RS-09-127
September 15, 2009U. S. Nuclear Regulatory Commission
ATTN: Document Control Desk
Washington, DC 20555-0001

Braidwood Station, Units 1 and 2
Facility Operating License Nos. NPF-72 and NPF-77
NRC Docket Nos. STN 50-456 and STN 50-457

Byron Station, Units 1 and 2
Facility Operating License Nos. NPF-37 and NPF-66
NRC Docket Nos. STN 50-454 and STN 50-455

Subject: Revised Information Supporting License Amendment Request
Regarding Technical Specifications (TS) for Steam Generator
Permanent Alternate Repair Criteria

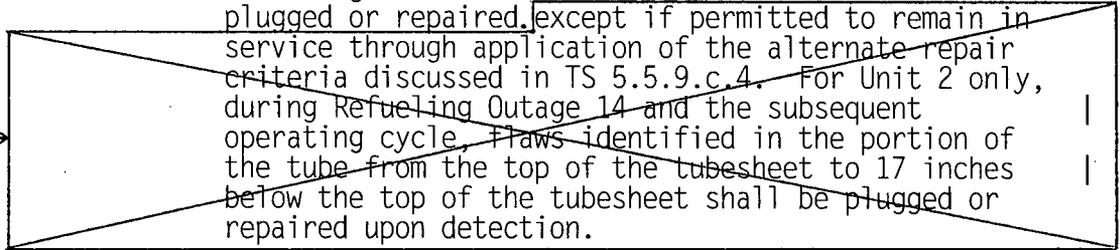
1. Tubes found by inservice inspection to contain flaws in a non-sleeved region with a depth equal to or exceeding 40% of the nominal wall thickness shall be plugged or repaired, ~~except if permitted to remain in service through application of the alternate repair criteria discussed in TS 5.5.9.c.4. For Unit 2 only, during Refueling Outage 14 and the subsequent operating cycle, flaws identified in the portion of the tube from the top of the tubesheet to 17 inches below the top of the tubesheet shall be plugged or repaired upon detection.~~

INSERT 1

The following alternate tube repair criteria shall be applied as an alternative to the 40% depth based criteria:

For Unit 2 during Refueling Outage 15 and the subsequent operating cycle, tubes with service-induced flaws located greater than 16.95 inches below the top of the tubesheet do not require plugging or repair. Tubes with service-induced flaws located in the portion of the tube from the top of the tubesheet to 16.95 inches below the top of the tubesheet shall be plugged or repaired upon detection.

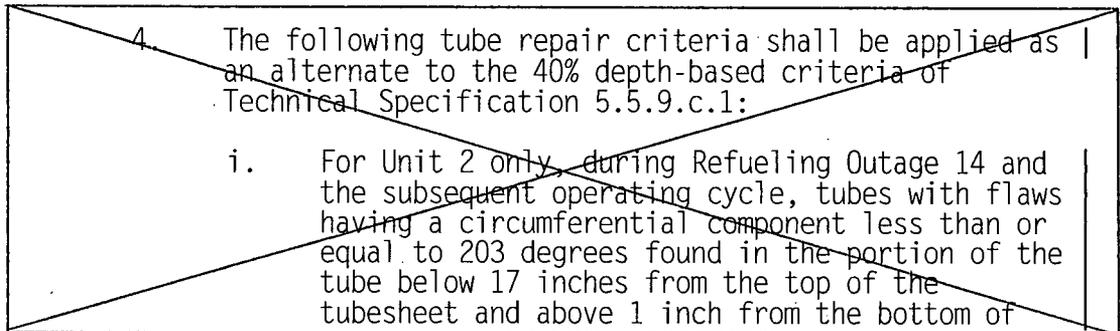
2. Sleeves found by inservice inspection to contain flaws with a depth equal to or exceeding the following percentages of the nominal sleeve wall thickness shall be plugged:
 - i. For Unit 2 only, TIG welded sleeves (per TS 5.5.9.f.2.i): 32%
3. Tubes with a flaw in a sleeve to tube joint that occurs in the sleeve or in the original tube wall of the joint shall be plugged.

4. The following tube repair criteria shall be applied as an alternate to the 40% depth-based criteria of Technical Specification 5.5.9.c.1:
 - i. For Unit 2 only, during Refueling Outage 14 and the subsequent operating cycle, tubes with flaws having a circumferential component less than or equal to 203 degrees found in the portion of the tube below 17 inches from the top of the tubesheet and above 1 inch from the bottom of

5.6.9 Steam Generator (SG) Tube Inspection Report

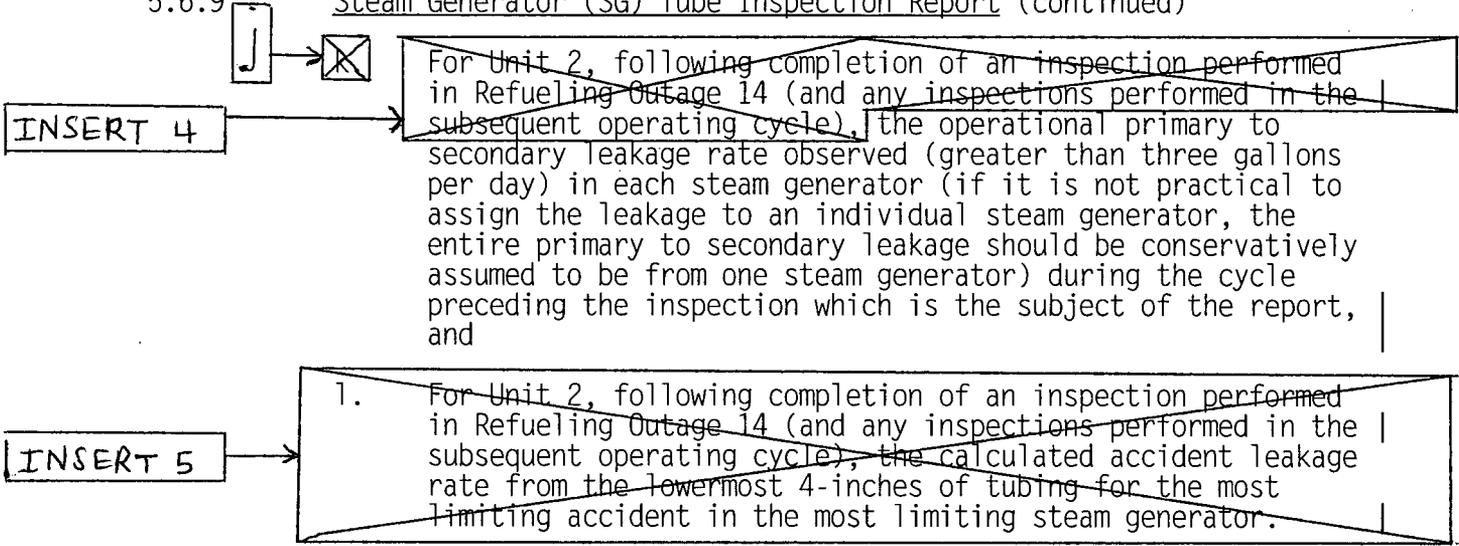
A report shall be submitted within 180 days after the initial entry into MODE 4 following completion of an inspection performed in accordance with Specification 5.5.9, Steam Generator (SG) Program. The report shall include:

- a. The scope of inspections performed on each SG,
- b. Active degradation mechanisms found,
- c. Nondestructive examination techniques utilized for each degradation mechanism,
- d. Location, orientation (if linear), and measured sizes (if available) of service induced indications,
- e. Number of tubes plugged or repaired during the inspection outage for each active degradation mechanism,
- f. Total number and percentage of tubes plugged or repaired to date,
- g. The results of condition monitoring, including the results of tube pulls and in-situ testing,
- h. The effective plugging percentage for all plugging and tube repairs in each SG, and
- i. Repair method utilized and the number of tubes repaired by each repair method.

- ~~j. For Unit 2, following completion of an inspection performed in Refueling Outage 14 (and any inspections performed in the subsequent operating cycle), the number of indications and location, size, orientation, and whether initiated on primary or secondary side for each service-induced flaw detected within the thickness of the tubesheet, and the total of the circumferential components and any circumferential overlap below 17 inches from the top of the tubesheet, as determined in accordance with TS 5.5.9 c.4.i,~~

INSERT 4

For Unit 2 following completion of an inspection performed in Refueling Outage 15 (and any inspections performed in the subsequent operating cycle),

INSERT 5

- k. For Unit 2 following completion of an inspection performed in Refueling Outage 15 (and any inspections performed in the subsequent operating cycle), the calculated accident induced leakage rate from the portion of the tubes below 16.95 inches from the top of the tubesheet for the most limiting accident in the most limiting SG. In addition, if the calculated accident induced leakage rate from the most limiting accident is less than 3.11 times the maximum operational primary to secondary leakage rate, the report should describe how it was determined, and

- l. For Unit 2 following completion of an inspection performed in Refueling Outage 15 (and any inspections performed in the subsequent operating cycle), the results of monitoring for tube axial displacement (slippage). If slippage is discovered, the implications of the discovery and corrective action shall be provided.
